Central Valley Regional Water Quality Control Board

WESTERN SAN JOAQUIN RIVER WATERSHED COALITION – APPROVAL OF THE 2016 MONITORING PLAN UPDATE

SUBJECT: MONITORING PLAN UPDATE FOR MARCH 2015 THROUGH FEBRUARY 2017– WESTERN SAN JOAQUIN RIVER WATERSHED COALITION

Figure 1. Weekly selenium concentrations in San Luis Canal upstream of Splits (Site L2). Also shown is the 2 µg/L water quality objective for selenium in wetlands (monthly mean).

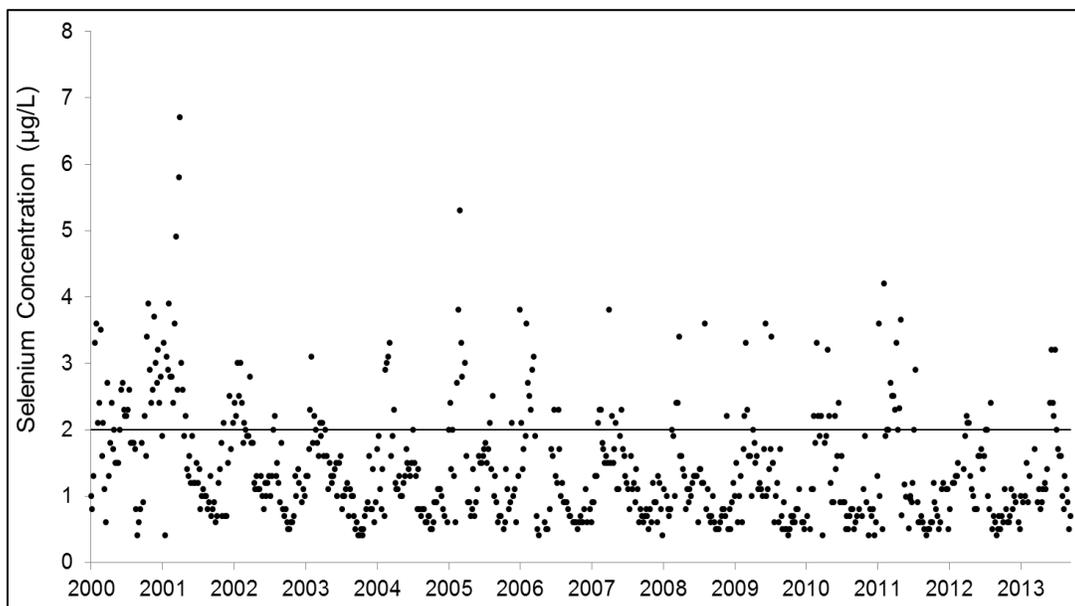
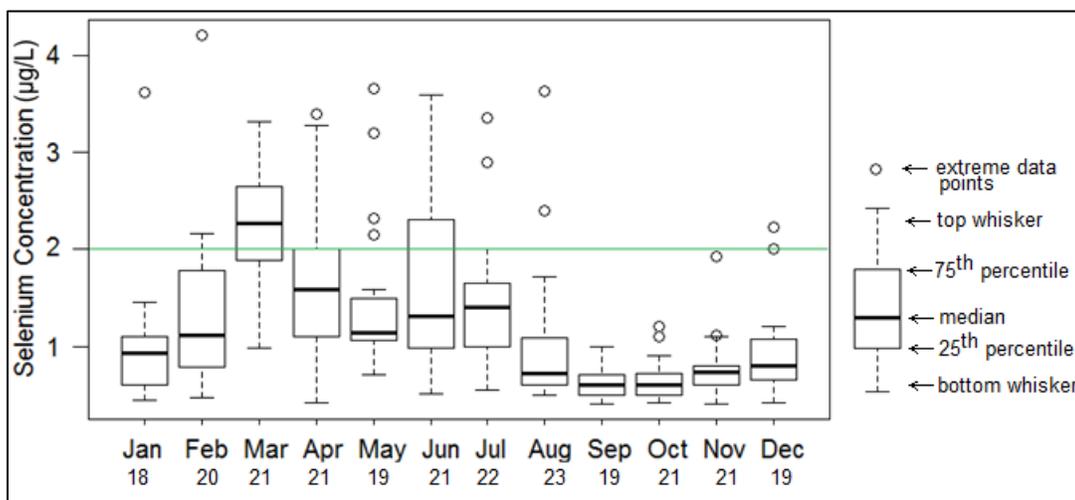
- **San Luis Canal upstream of Splits (Site L2).** Selenium concentrations in the wetland supply channels exhibit a seasonal pattern (Figures 1 and 2).

Staff examined the most recent five years of weekly selenium measurements in order to capture the water quality in wetland supply channels representative of the crops and management practices currently in place. Selenium concentrations in more than 90% of weekly samples collected and analyzed between 2008 and 2013 have been below the water quality objective from August through January (Figure 2). Despite occasional exceedances of the selenium water quality objective (fewer than 10% of results), monthly monitoring of selenium is likely to capture the representative concentration at Site L2, and staff agrees with the proposed frequency during the period from August

through January. Weekly monitoring of selenium at Site L2 from February through July is also appropriate to capture the period when exceedances have been more frequent.

Figure 3. Weekly selenium concentrations in Santa Fe Canal upstream of Splits. Also shown is the 2 µg/L water quality objective for selenium in wetlands (monthly mean).

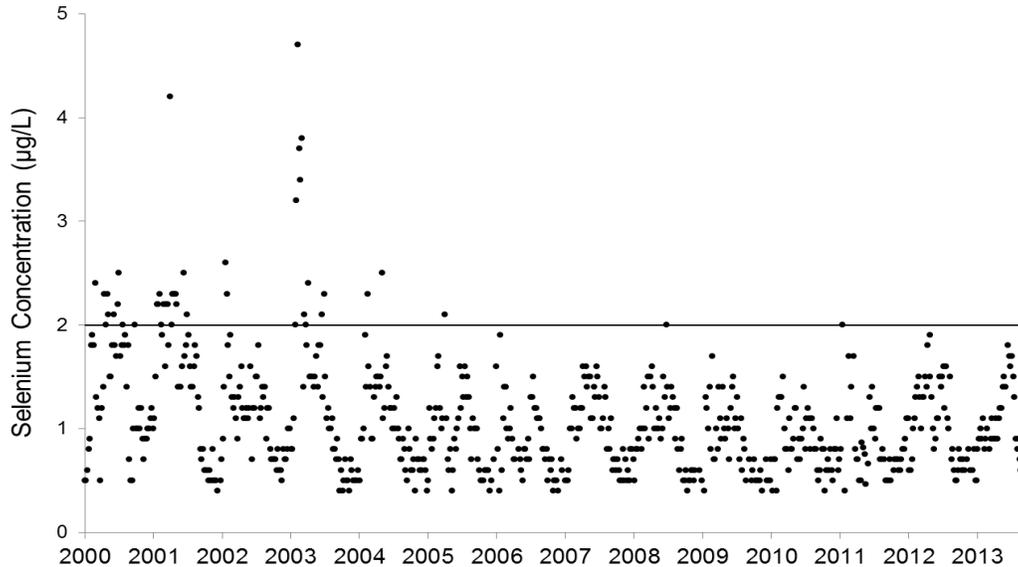
- **Santa Fe Canal upstream of Splits (Site M2).** The selenium water quality objective for wetlands has been achieved at Site M2 since 2003 (Figure 3). Staff agrees that proposed monthly monitoring is sufficient to capture the representative selenium concentration and track compliance with the water quality objective.
